1990 Corvette: Service Bulletin: Information on Door Lock System Components and Replacement Components

Model and Year: 1990 CORVETTE

Bulletin Number: 90-375-10 - (10/25/1990)

Figure 1

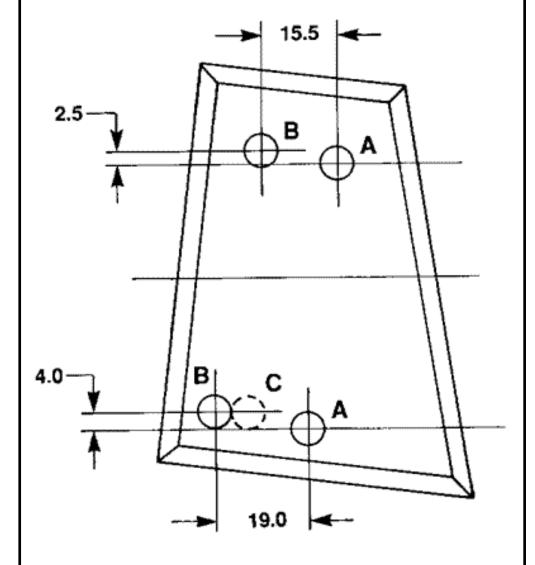
In addition to replacing the above components, it may be necessary to relocate the power door lock actuator on the door inner panel. Figure 1 will illustrate the hole patterns.

- If the actuator is located in the holes marked "A," it will not need to be relocated.

- If the actuator is located in the holes marked "B";
- remove the actuator by drilling out the attaching rivets.
- locate the new attaching holes ("A") using the dimensions on the illustration.
- attach the actuator in the new location using 1/4" X 1/2" peel type rivets.

IMPORTANT: Hole "C" may or may not be present. Relocate holes from "B" locations only.
